**PLANNING COMMISSION
STAFF REPORT**

September 20, 2018

AGENDA ITEM: Planning File No. 127-18-MAJ: A Major Site Plan review for the Woodhaven Townhomes multi-family residential project

Sketch Plan West Elevation

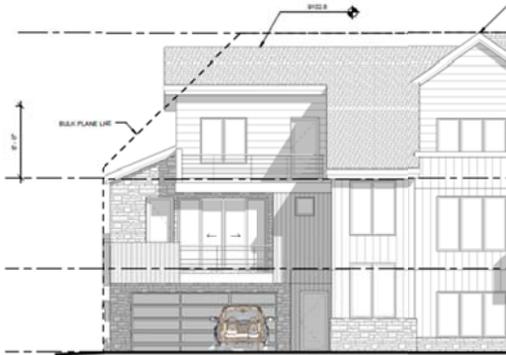
Bulk Standards (§180-6.23): The application shows bulk plane encroachments on the submitted elevation drawings. §180-6.23.3 of the UDC states that building forms may deviate from this standard and project beyond the bulk plane if they do not exceed maximum building height and provide substantial architectural relief, with Planning Commission approval. At the July 19, 2018 sketch plan meeting, Commissioners voiced concerns with the proposed bulkplane encroachments. In response to Commissioners concerns, the application has reduced the proposed bulkplane encroachments. See below comparisons of bulkplane encroachments illustrating encroachments proposed at sketch plan versus current proposed bulkplane encroachments.

Should the Planning Commission find that the encroachments provide substantial architectural relief and advance the intent of Section 180-6.23, then the application meets this standard.
